ADDENDUM No. 1

ITB No. 4576

Larcom Chiller Replacement Project

Drawing E-3 is revised as part of this Addendum

E-3

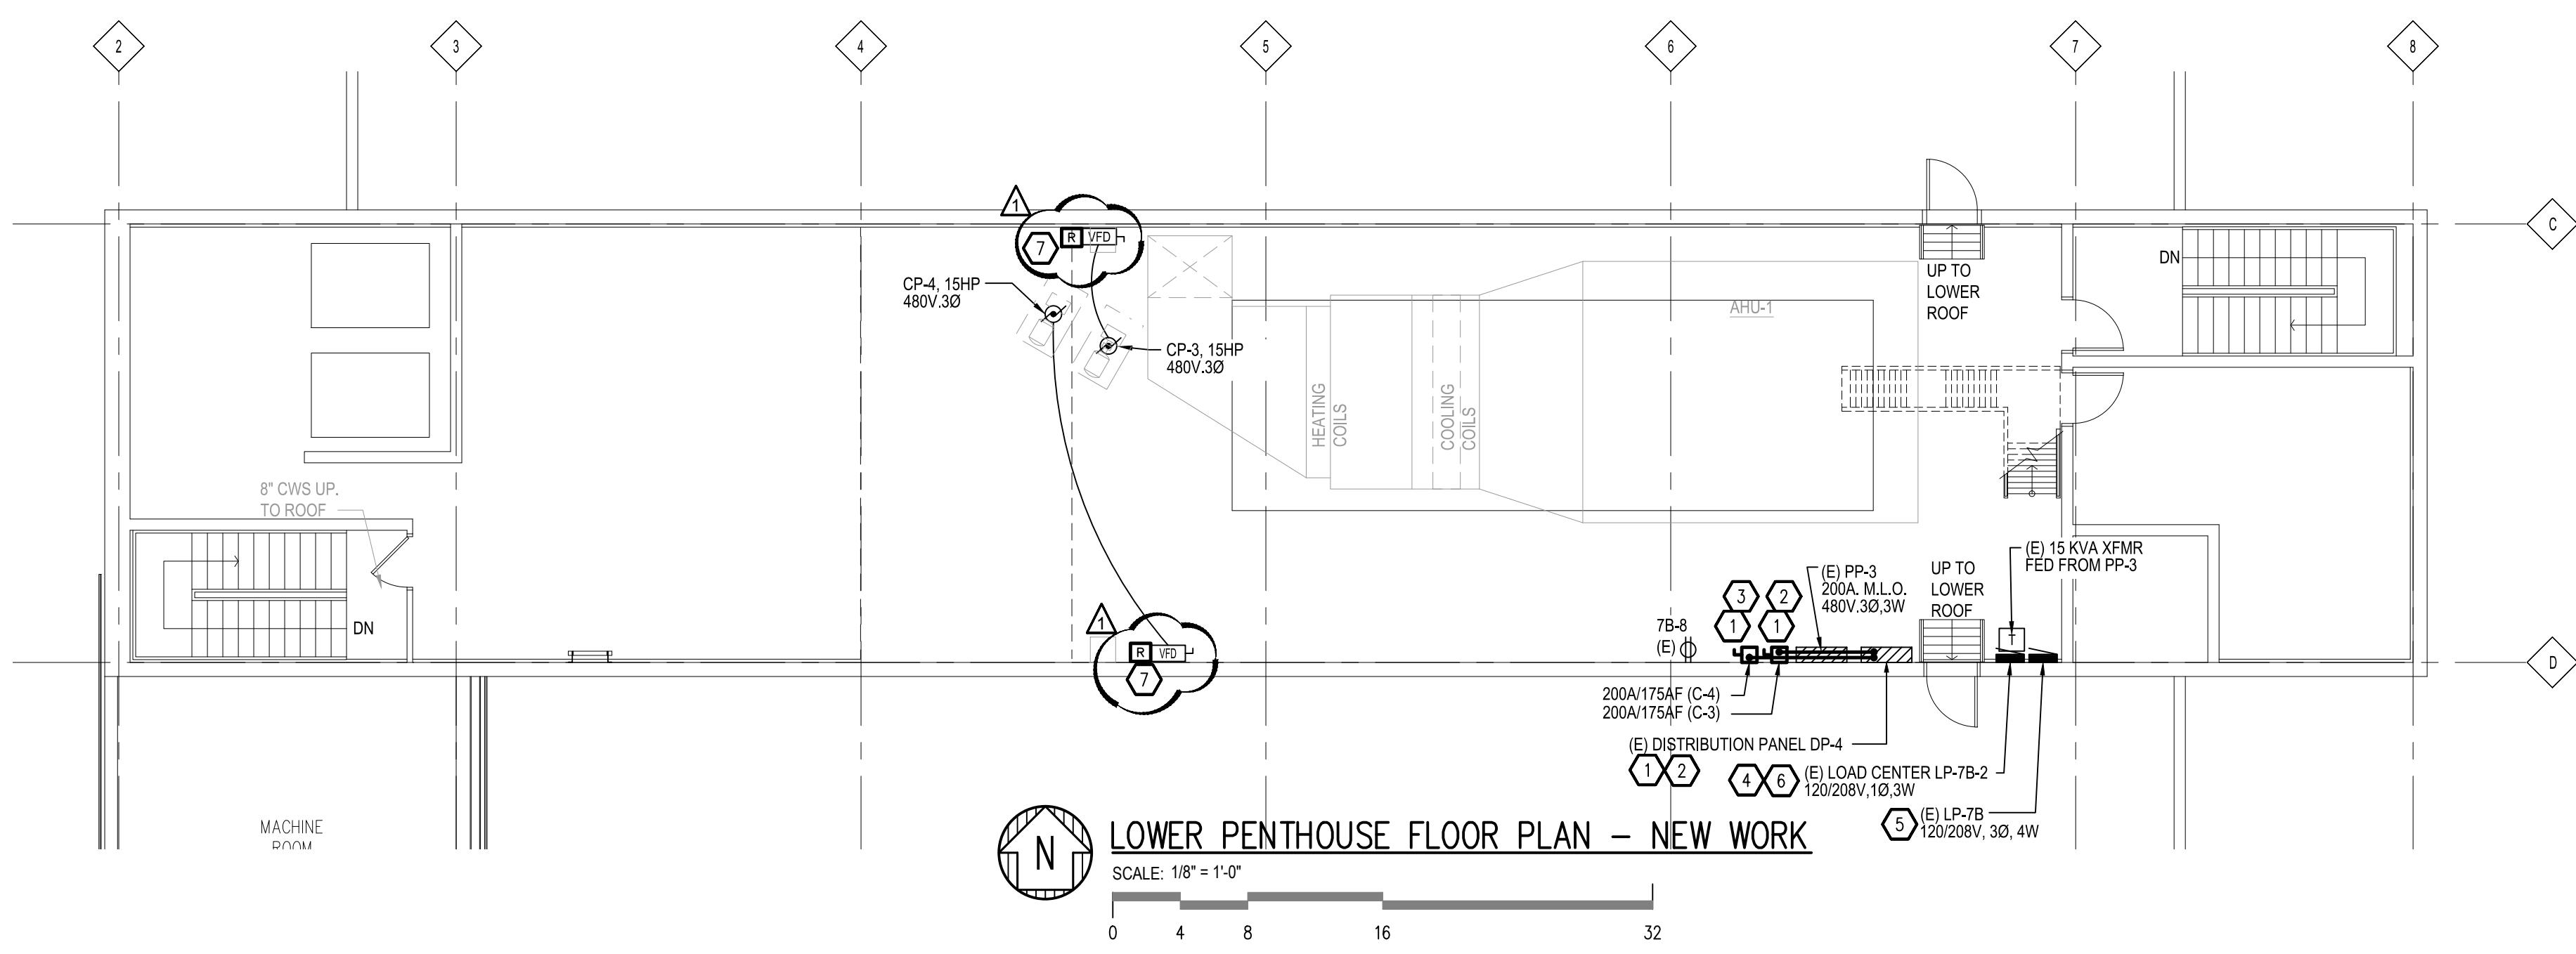
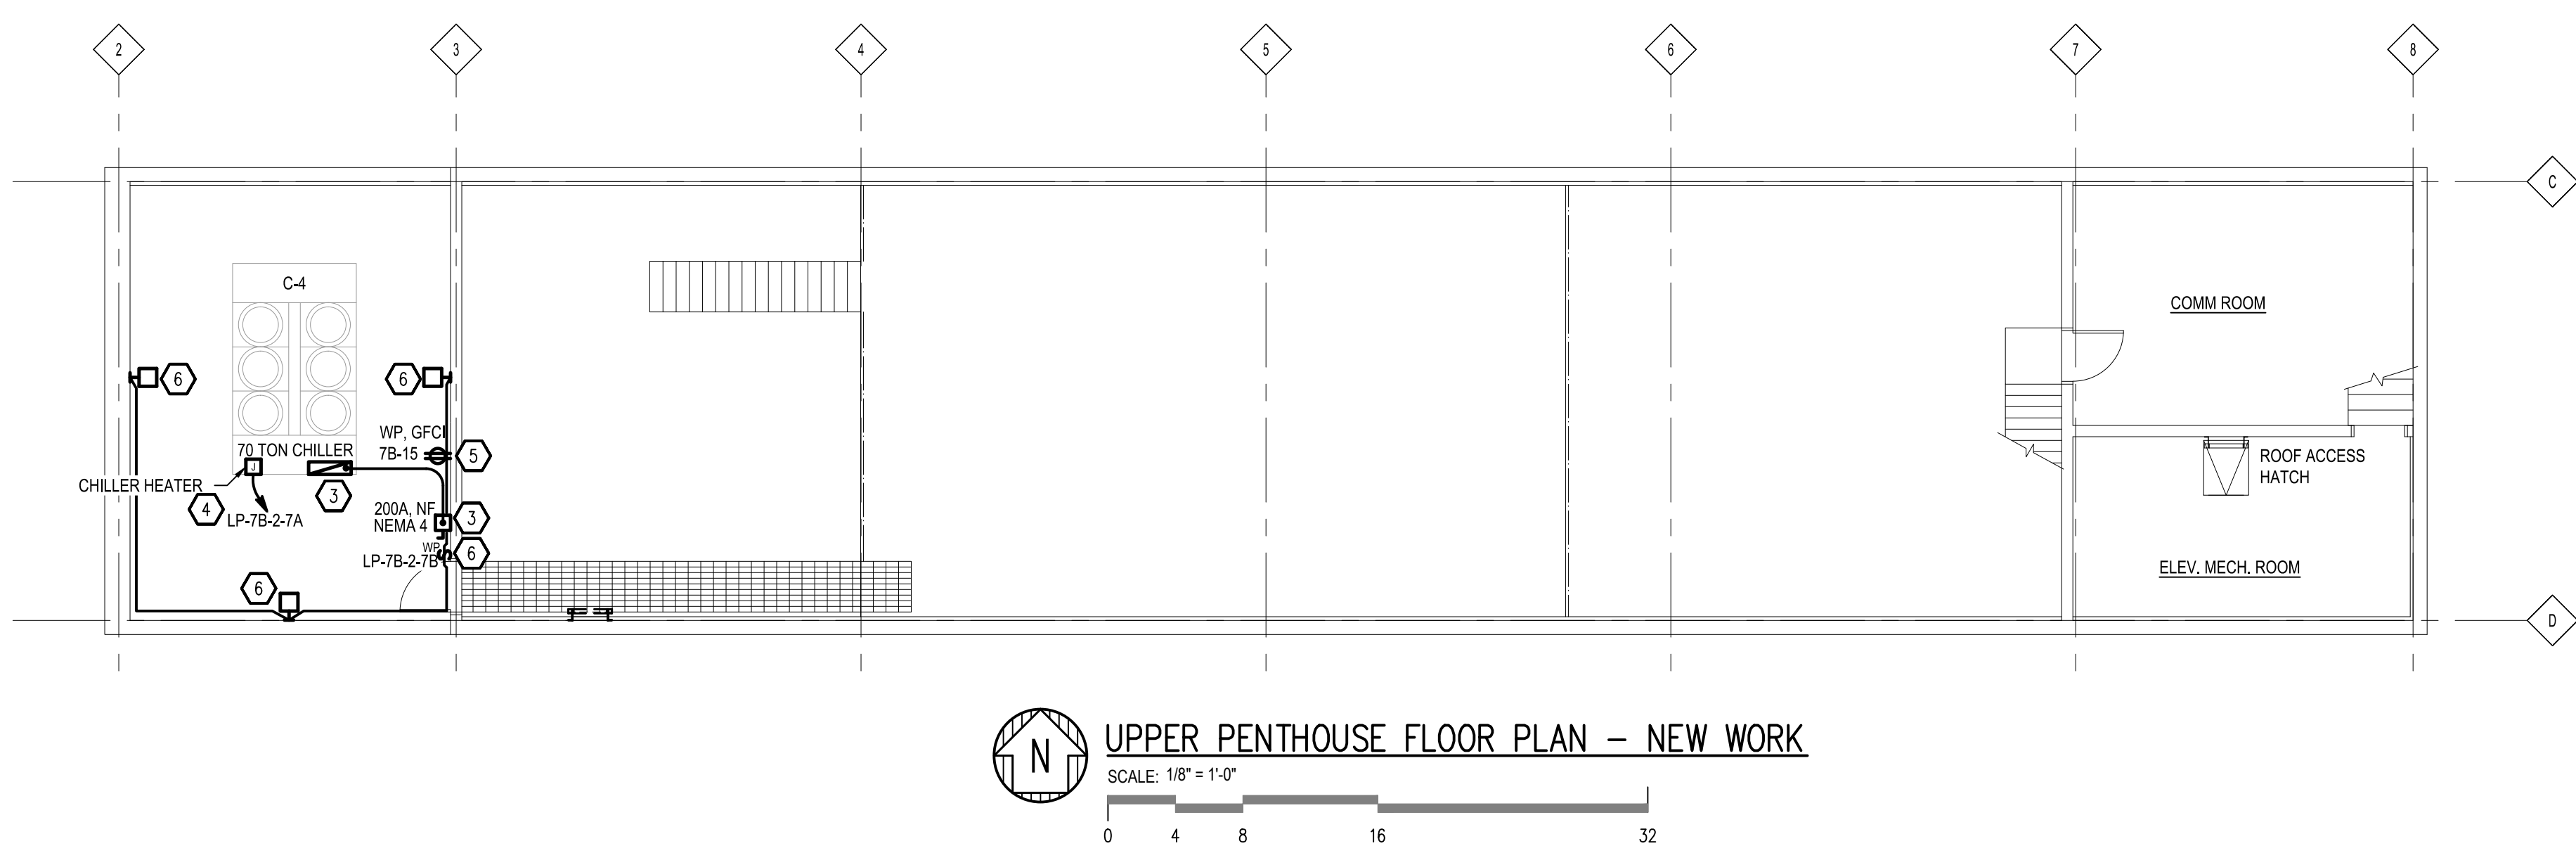
1. Refer to Drawing Sheet E-3 (Re-Issued):

a. Added New Work Key Note 7 as follows:

- “(7) Furnish, Install, and Connect 3% (1.2 mH, 480V, 3Ø) input line reactors for Chilled Water Pumps CP-3 and CP-4 Yaskawa Model CIMR-ZU4A0021FFA-166 Variable Speed Drives. Reactors shall have NEMA 1

enclosures and shall be Yaskawa or MTE RL-02512 with Cab-13V enclosure.”

- 7 FURNISH, INSTALL, AND CONNECT 3" (1.2 MM, 480V, 3Ø) INPUT LINE REACTORS FOR CHILLED WATER PUMPS CP-3 AND CP-4 YASKAWA MODEL CIMR-ZU40021FFA-166 VARIABLE SPEED DRIVES. REACTORS SHALL HAVE NEMA 1 ENCLOSURES AND SHALL BE YASKAWA OR MTE RL-02512 WITH CAB-13V ENCLOSURES.
